Albert Bridge House, Manchester

Stage 1 Road Safety Audit

Design Response Report

Curtins Ref: 085538-CUR-XX-XX-T-TP-00005

Dwg Title: **PROPOSED ACCESS ARRANGEMENT (SUBJECT TO s278 AGREEMENT)**

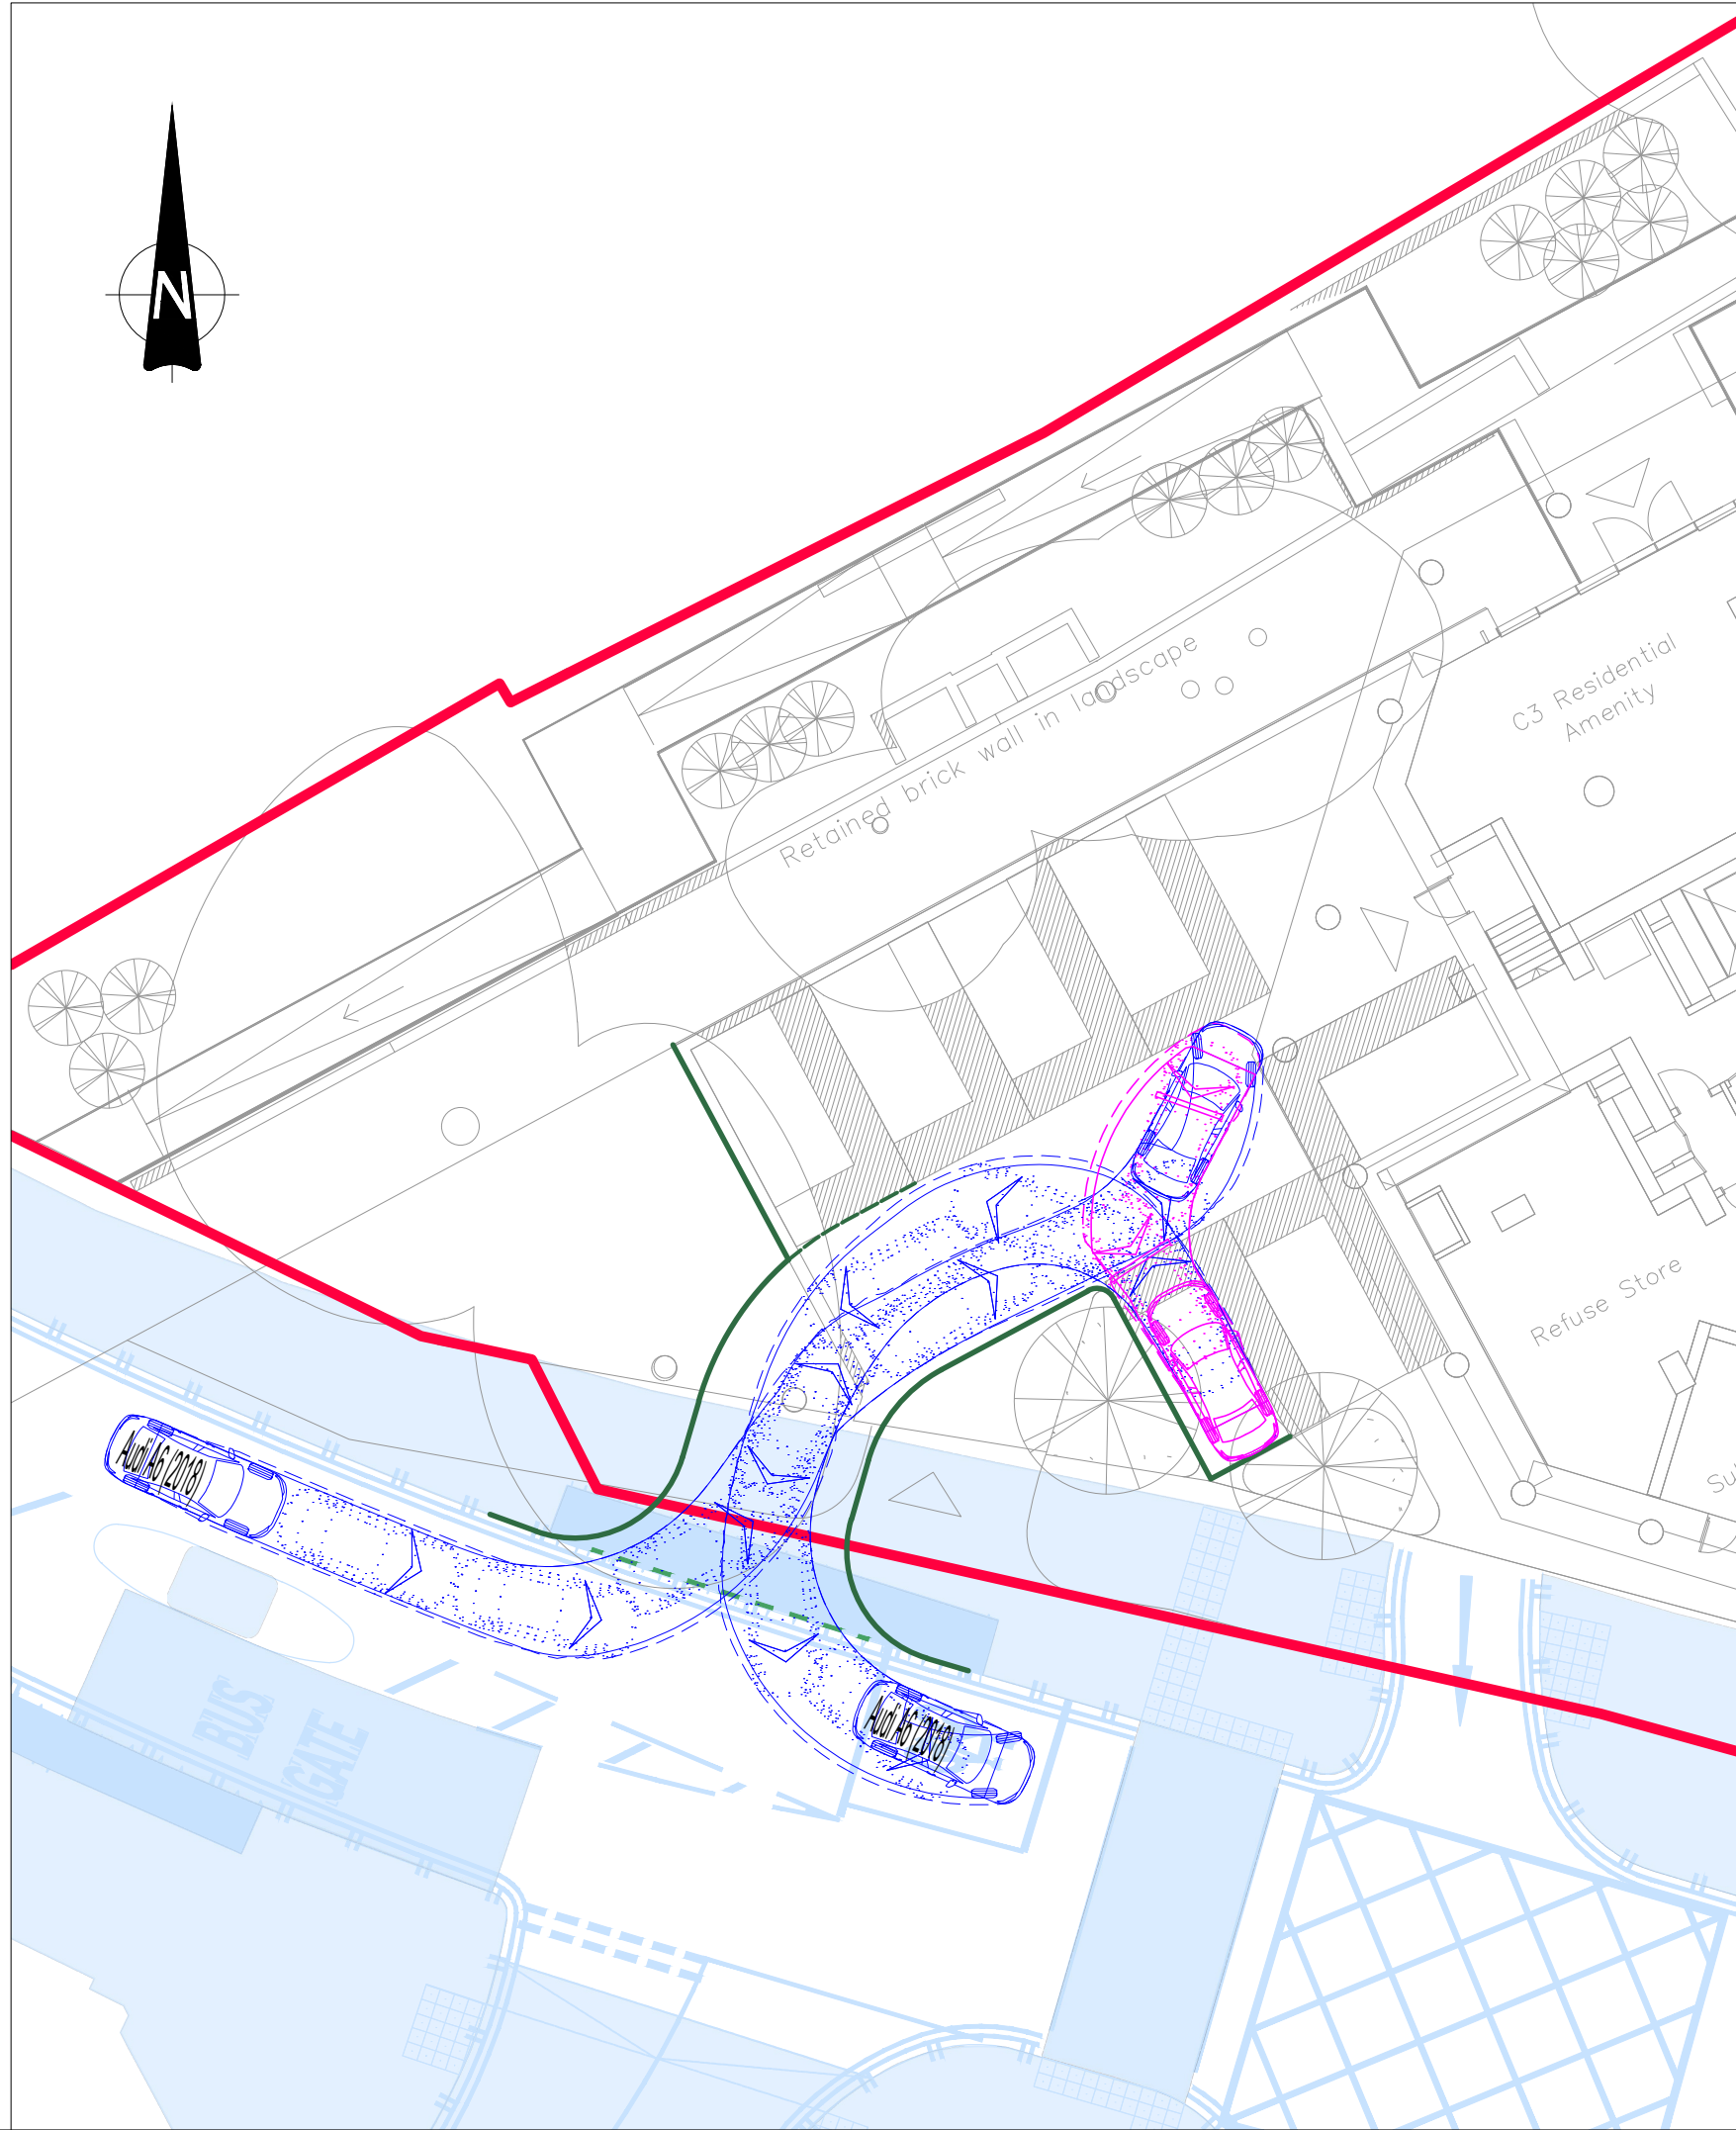
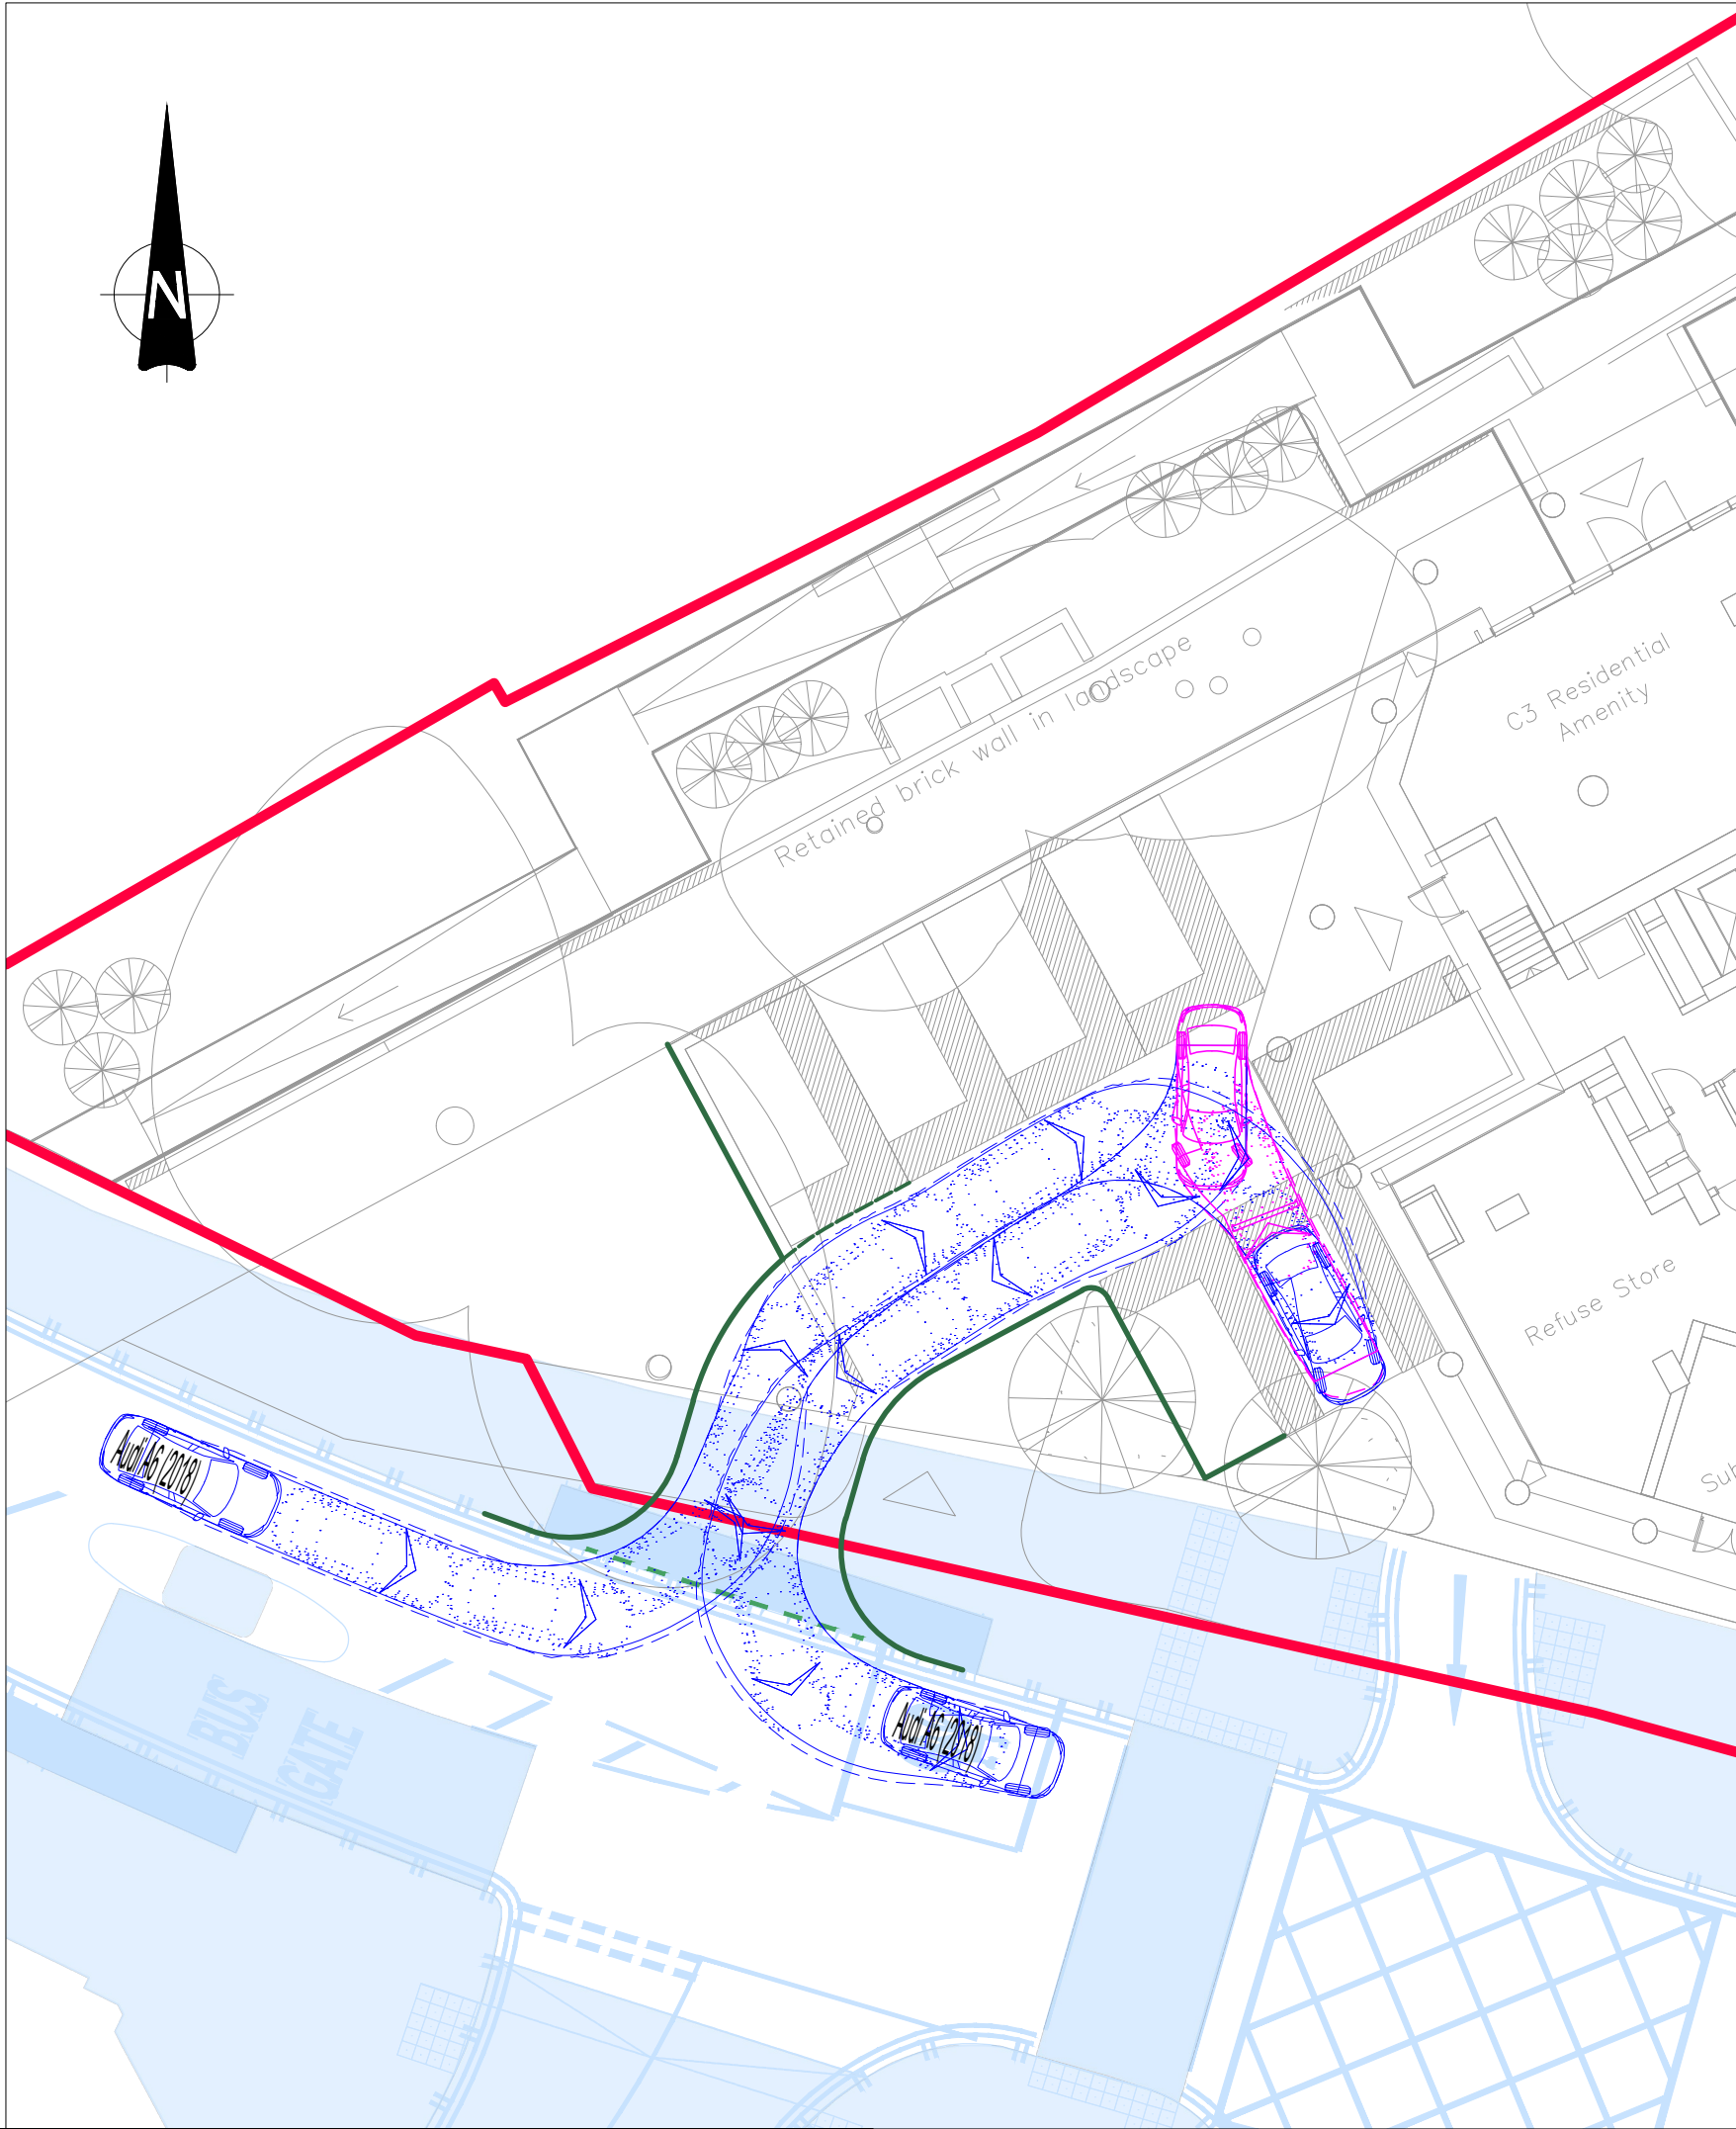
This access / egress will be newly constructed and located more towards a slight bend in Bridge Street. Although the alignment is good with a wide footway the auditor has no detail design proposal and note that there are existing large mature trees in the vicinity. The visibility afforded to drivers exiting the proposed development could be blocked by landscaping features resulting in side impact collisions between traffic on the main road and traffic emerging from the proposed development.

Ensure the visibility splay to the left and right are clear of obstructions by relocating the bus stop away from the visibility splays and restricting on-street parking.

There is a small refuge located in the vicinity of the planned access / egress and the audit team are concerned that this refuge may hinder drivers attempting to turn right out of the small car park which may result in unusual manoeuvres and conflict.

If right turn out of the car park is to be allowed, then the designer is to ensure there the refuge will not pose a problem for drivers turning efficiently and safely into Bridge Street.

Item	Location	Summary	Recommendation	Design Team Response
Problem – 4.1	Relocated access / egress (small car park) Bridge Street opposite Leftbank	Potential for restricted visibility to the right for traffic exiting the proposed development and potential for low-speed side impact crash types. This access / egress will be newly constructed and located more towards a slight bend in Bridge Street. Although the alignment is good with a wide footway the auditor has no detail design proposal and note that there are existing large mature trees in the vicinity. The visibility afforded to drivers exiting the proposed development could be blocked by landscaping features resulting in side impact collisions between traffic on the main road and traffic emerging from the proposed development.	Ensure the visibility splay to the left and right are clear of obstructions by relocating the bus stop away from the visibility splays and restricting on-street parking	The recommendation is accepted. Drawing ref.: “86313-CUR-XX-00-D-TP-75001” has been updated to revision P05 to show visibility splays in both directions from the proposed car park access. The updated drawing is shown in Appendix B
